L190-E980586-00-D

ENGINEERING CHANGE REQUEST (ECR)

DRAWING TITLE LIGO CLD Spring

REVISION: FROM 01 TO A

HYTEC, INC		HYTEC, INC	
LIGO ISOLATION SYSTEM COIL SPRING		LIGO ISOLATION SYSTEM COIL SPRING	
D972216-1		D972216 D 1 of 3

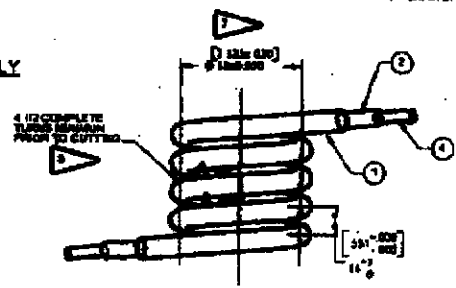
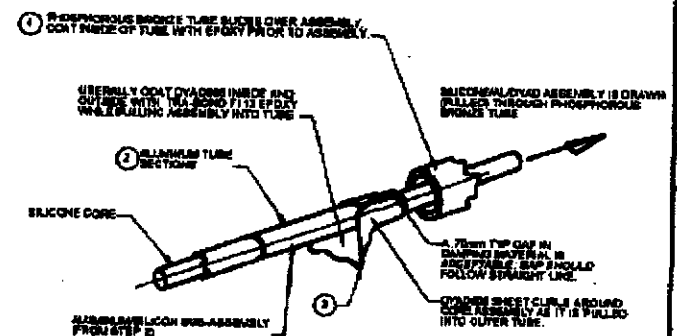
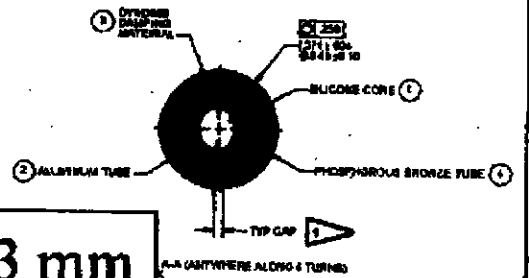
1. Incorporate new gapping on aluminum slugs
WAS 7.72 now 10.00mm
2. Update the drawing to current mfg plans
(see attached).

Now 10 mm was 7.72

Now 4.44 mm was 3.43 mm
